CITY OF ST. AUGUSTINE HISTORIC ARCHITECTURAL REVIEW BOARD

A G E N D A - **AMENDED***

THURSDAY, FEBRUARY 18, 2021 - 1:00 PM

PROPOSED DECK PLAN

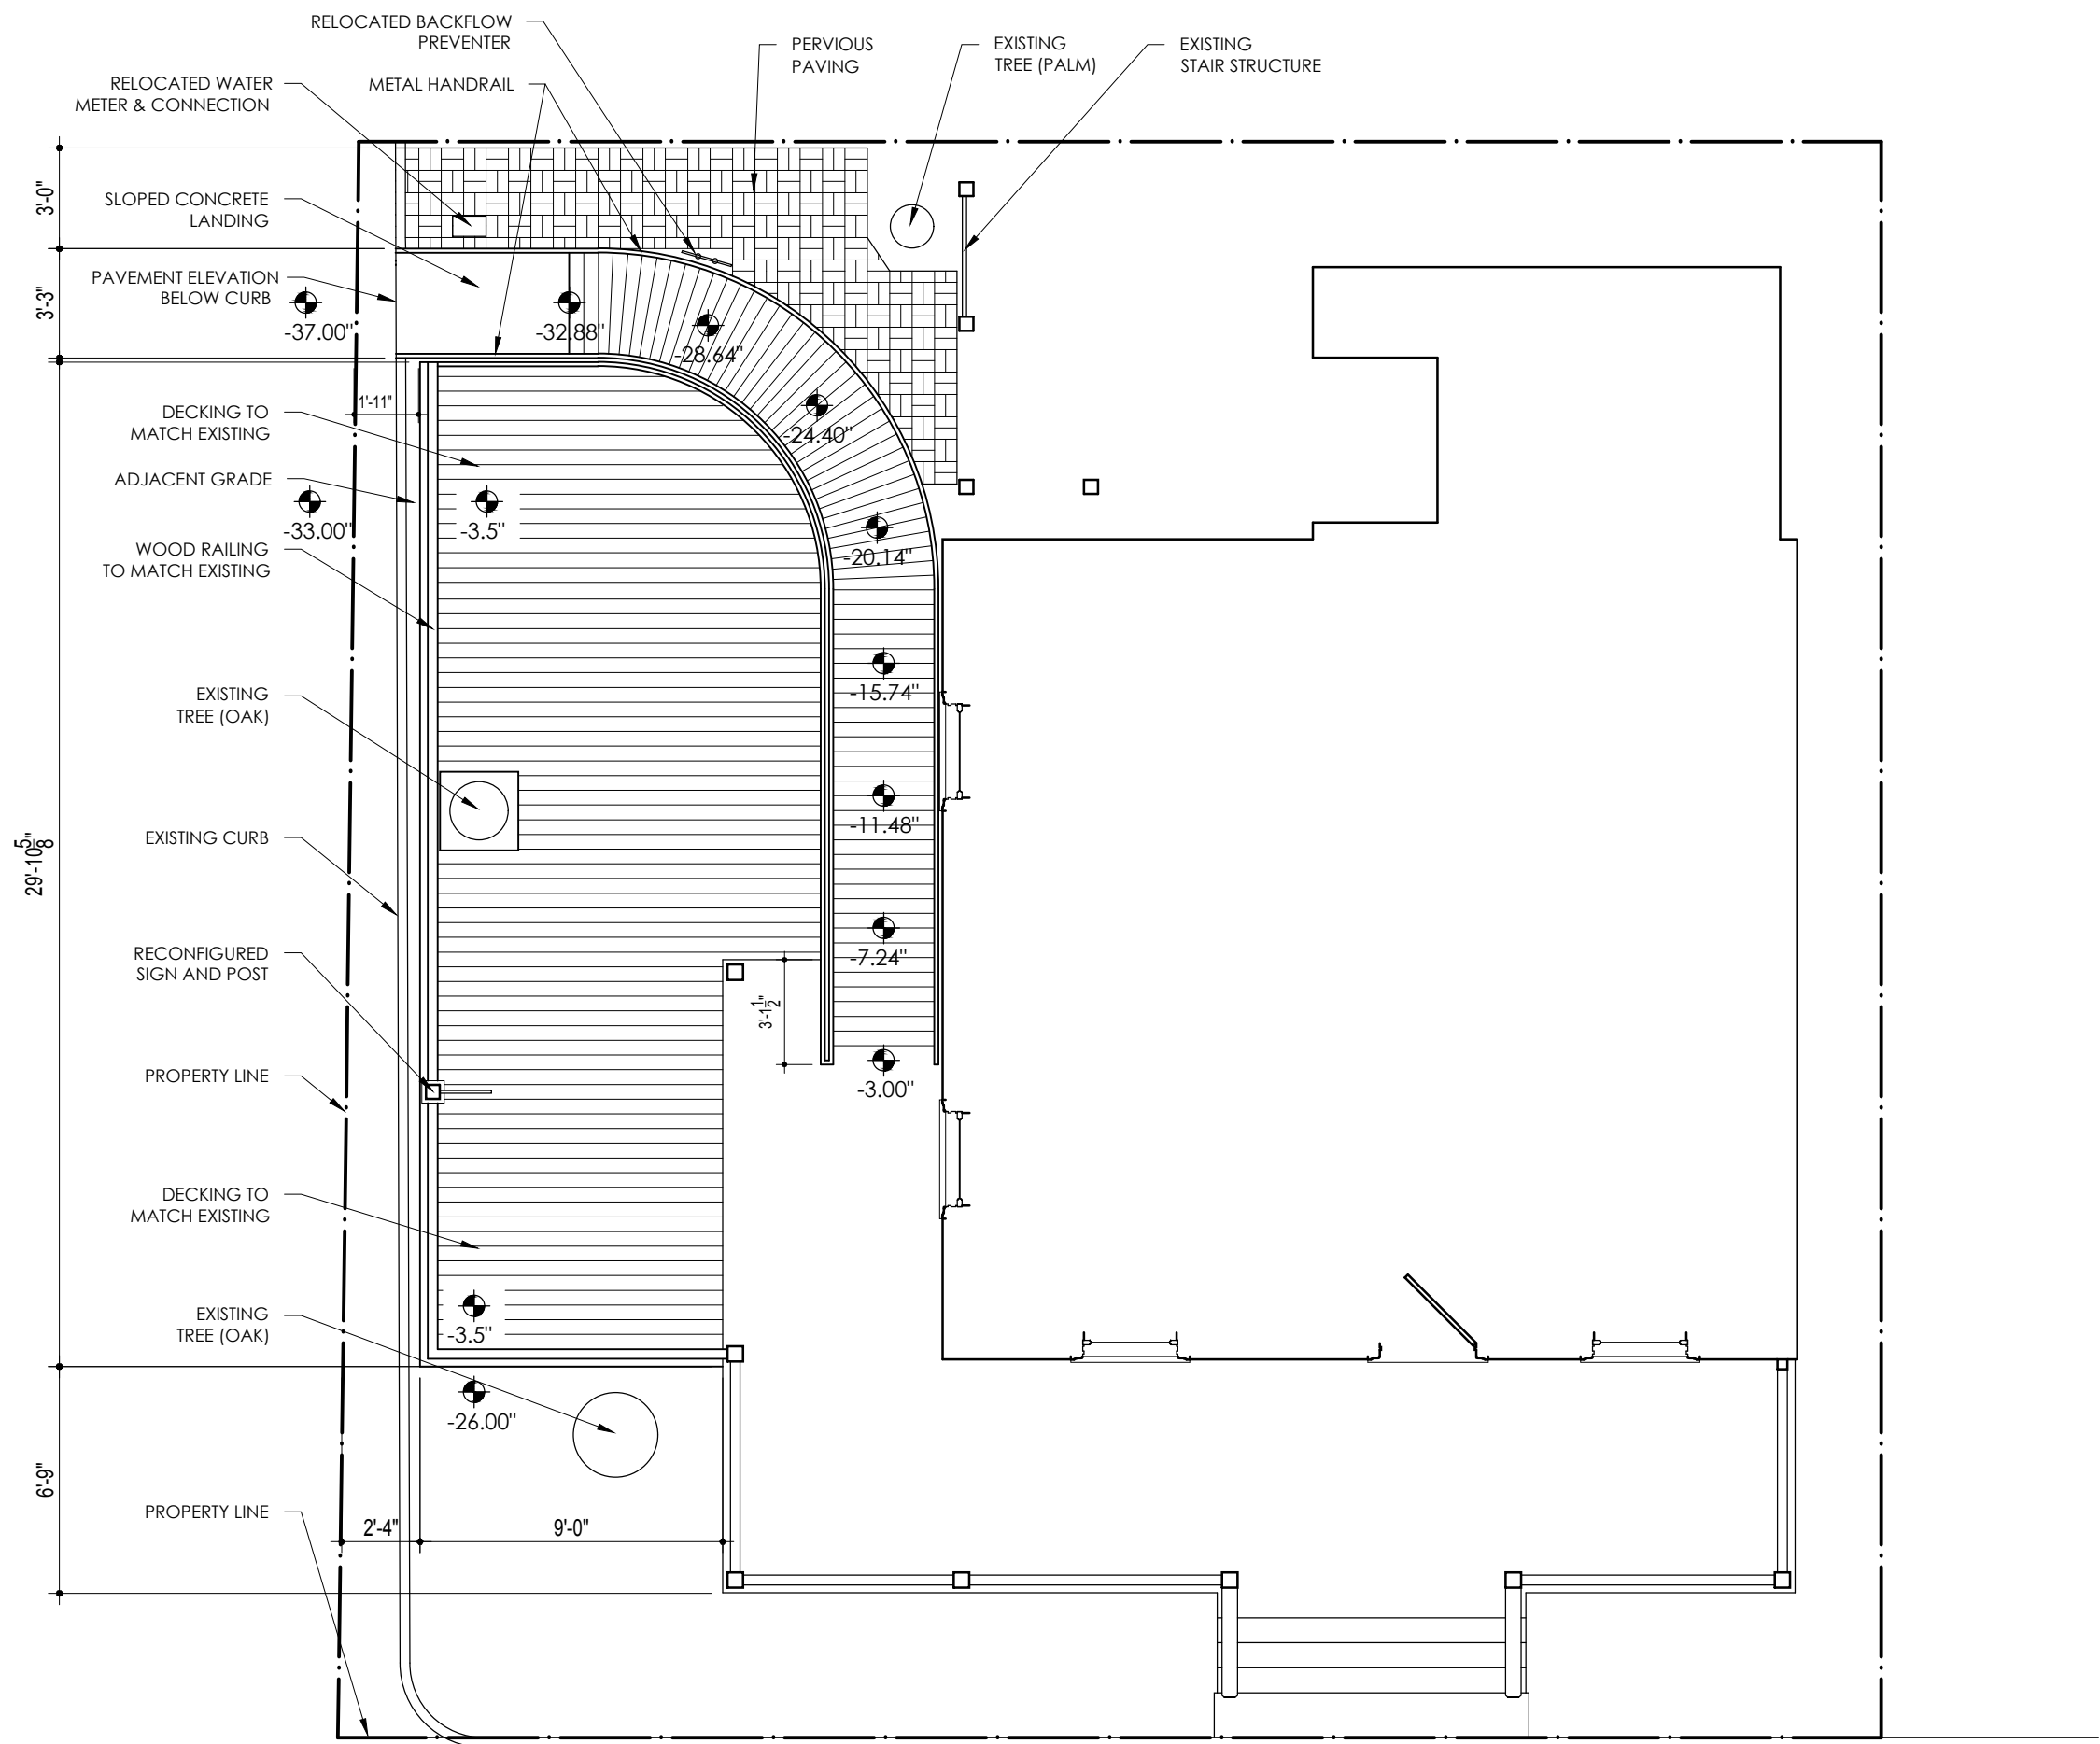
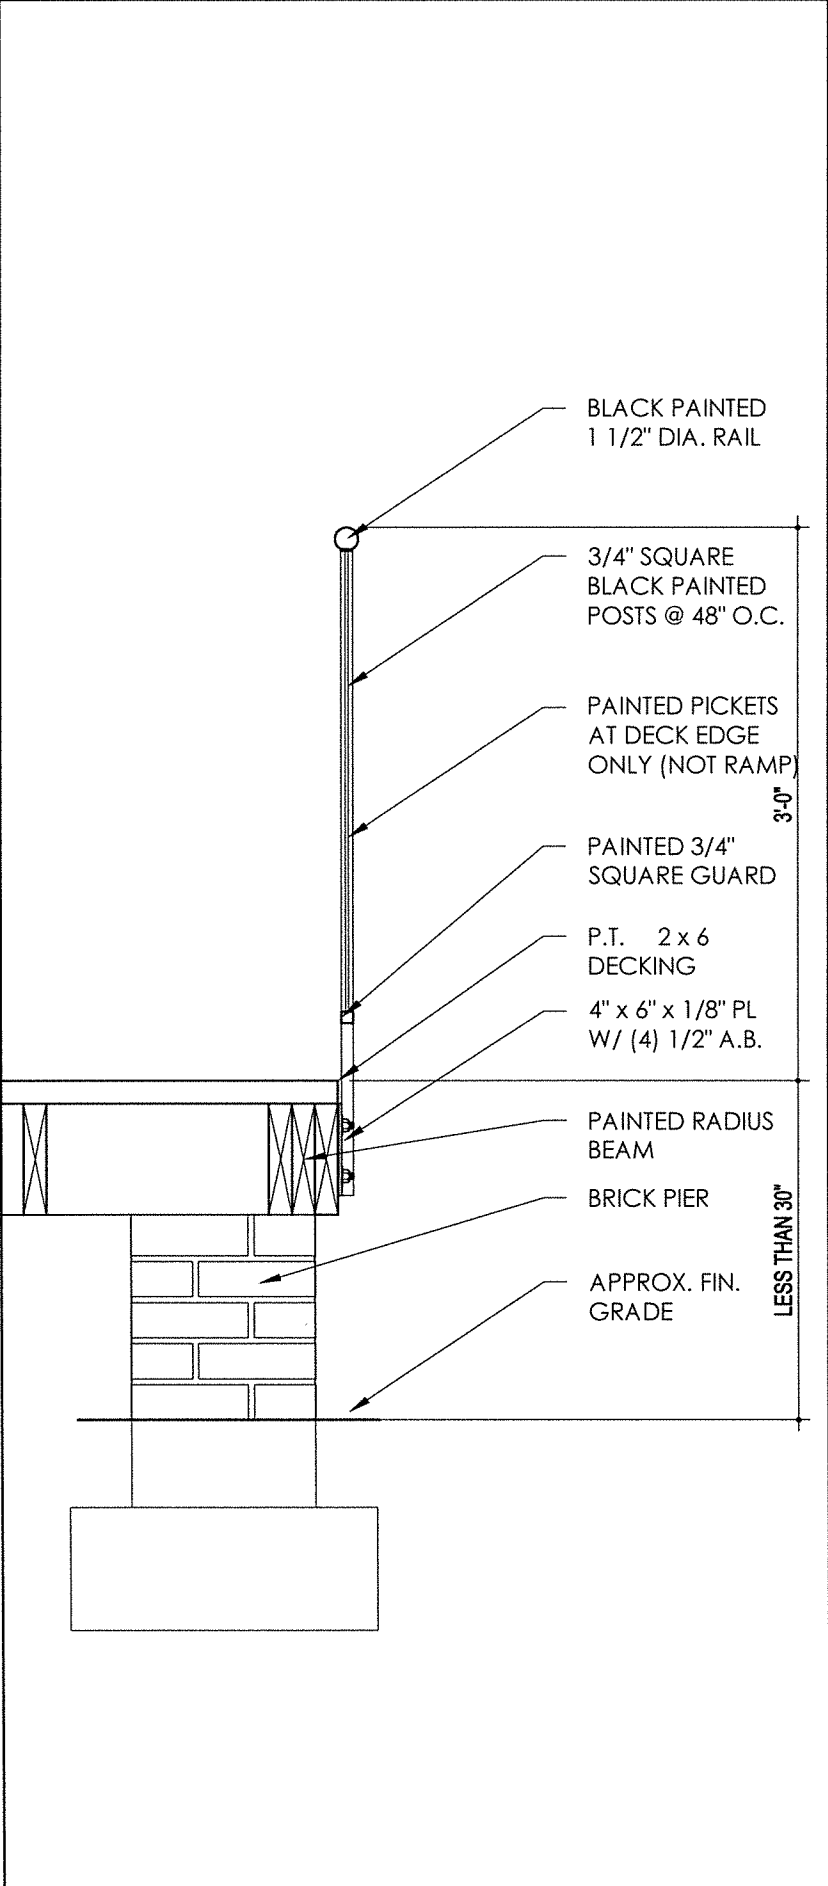
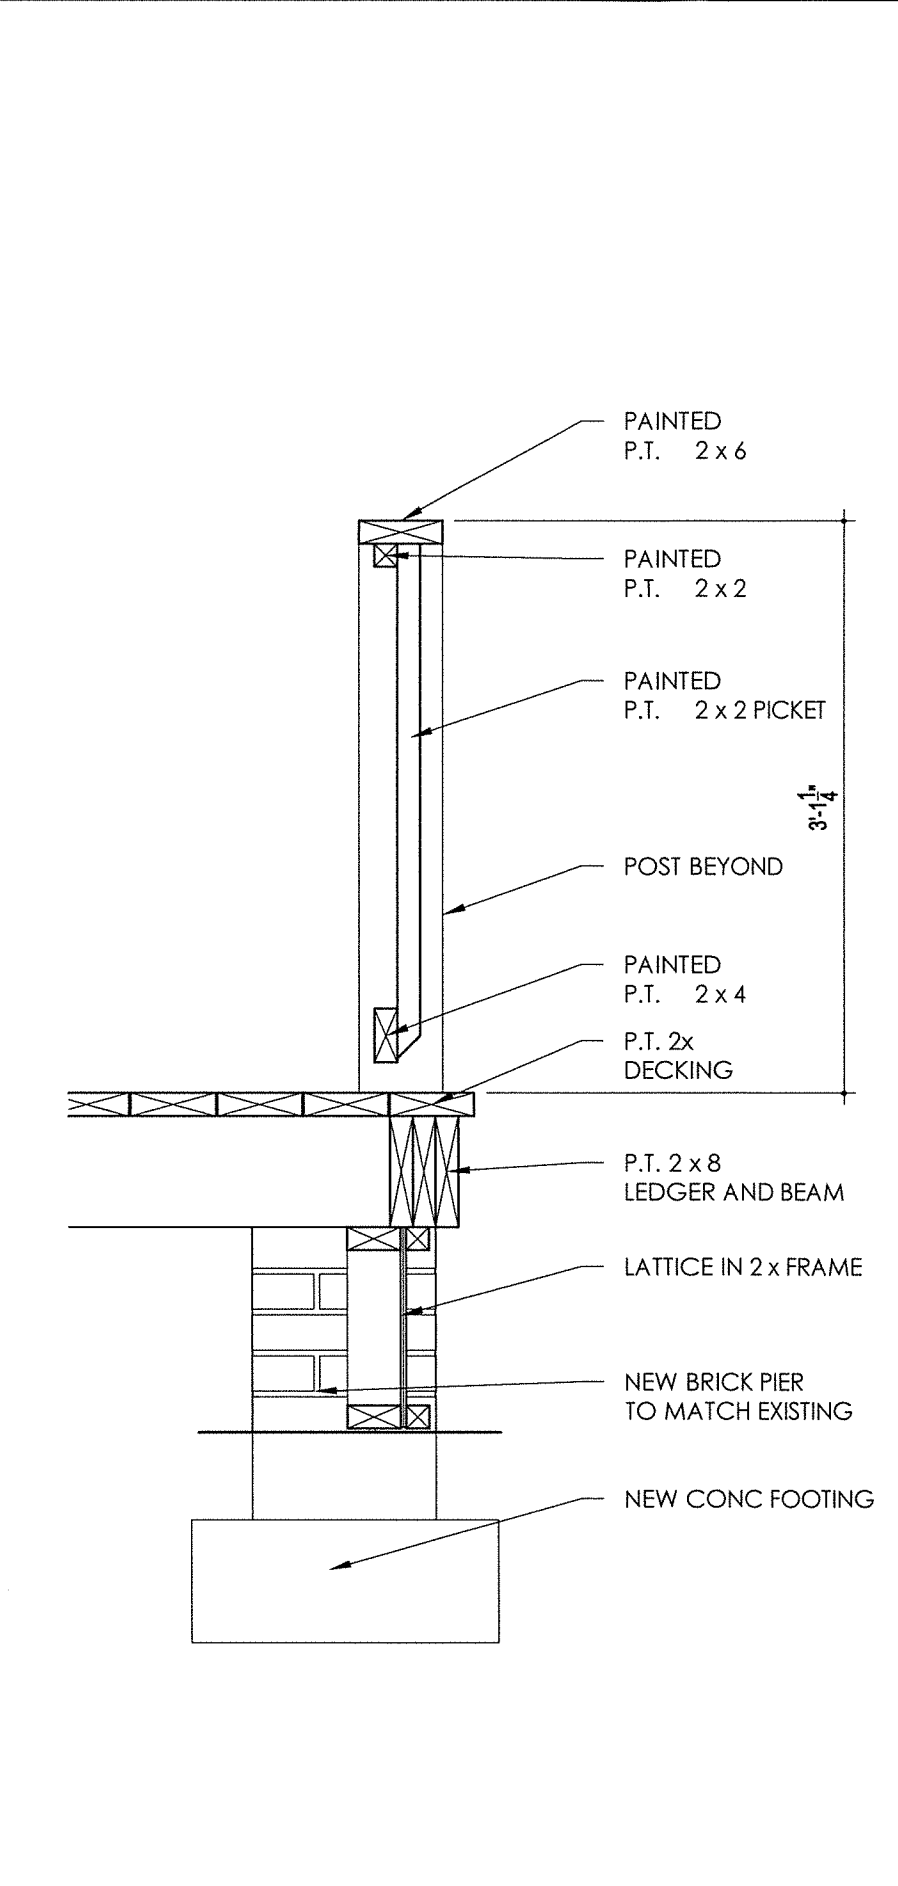
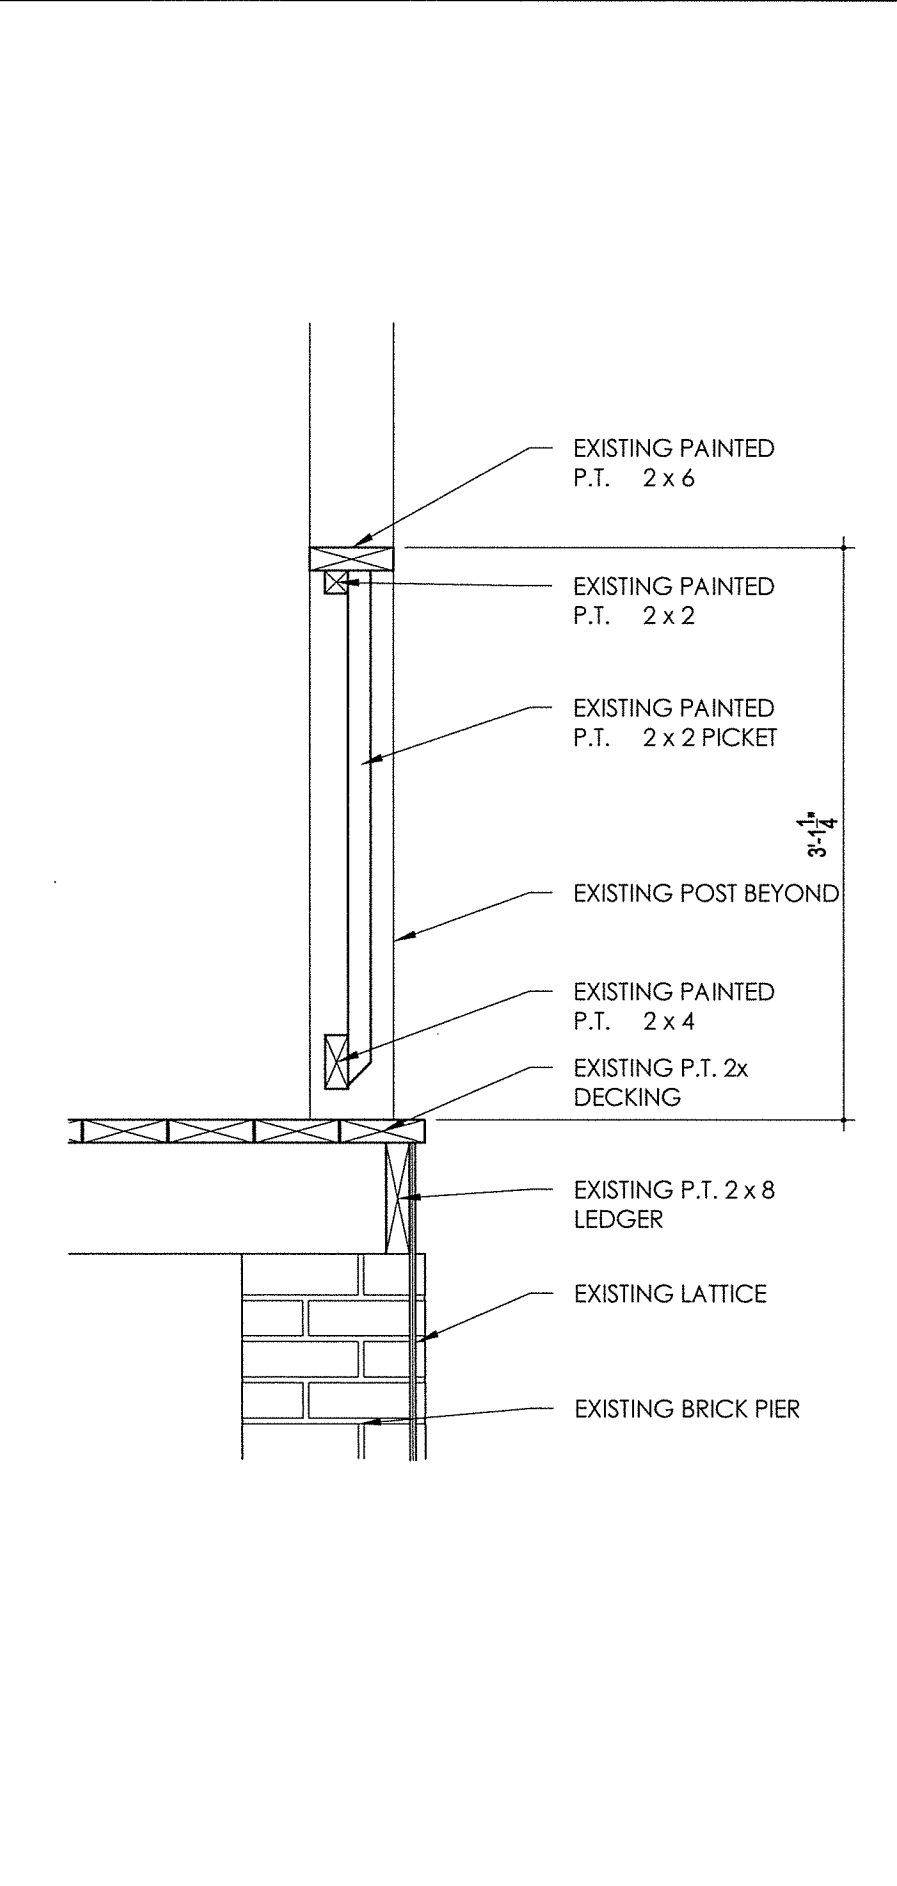
- The pervious pavers proposed on the northwest corner of the property look to have a similar appearance as clay pavers, one of the materials recommended in the AGHP for paving, but will have an added benefit of preventing water run-off. A sample should be provided to ensure it is compatible with the AGHP.

1. Change the ADA ramp hand rail design to a more architecturally compatible profile
2. For an appropriate finish to be applied to pressure treated wood members after installation if species used is visually yellow
3. Confirmation that the proposed pervious pavers are compatible with the AGHP

*Need info on pervious paving (see above)
Need more detail on wood species + finish for all proposed decking + railing, + lattice. Info + detail on sign + post, finish + size detail on steel handrail. Spec + photo on outdoor furniture.*

2 FRONT PORCH & ENTRY STAIRS SECTION
3/4" = 1'-0"

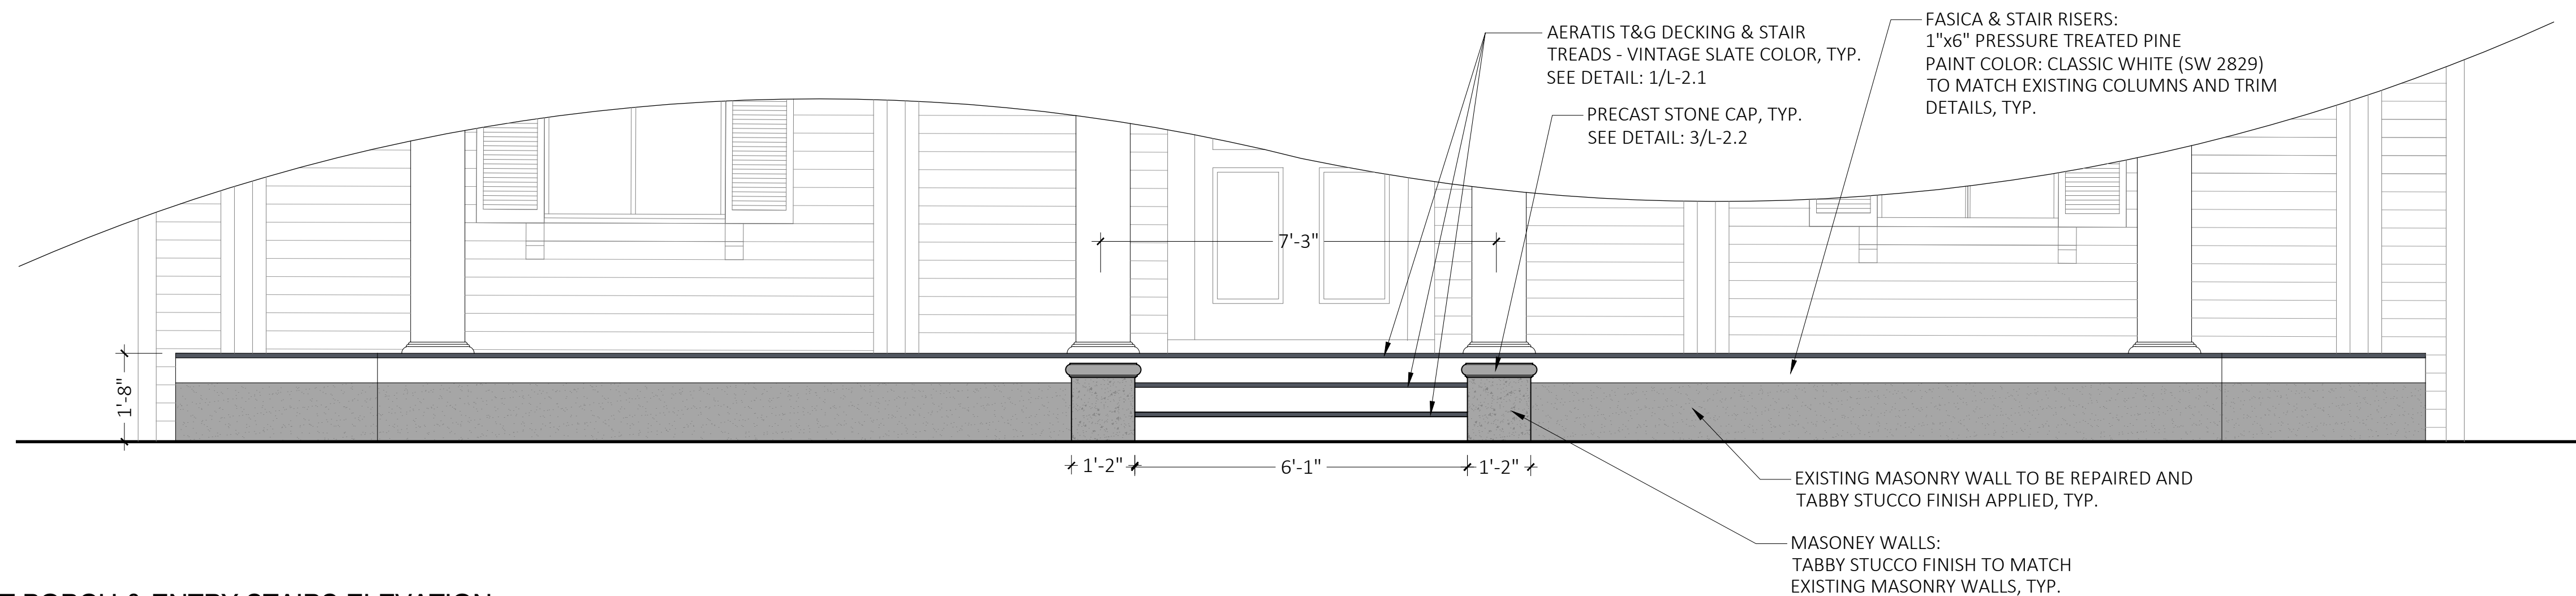
- A number of plants proposed, along with the grass species, are neither on the AGHP's list of compatible plants or a Florida native. Any plantings shall conform to the AGHP or be listed as a Florida native plant, unless otherwise approved by HARB.
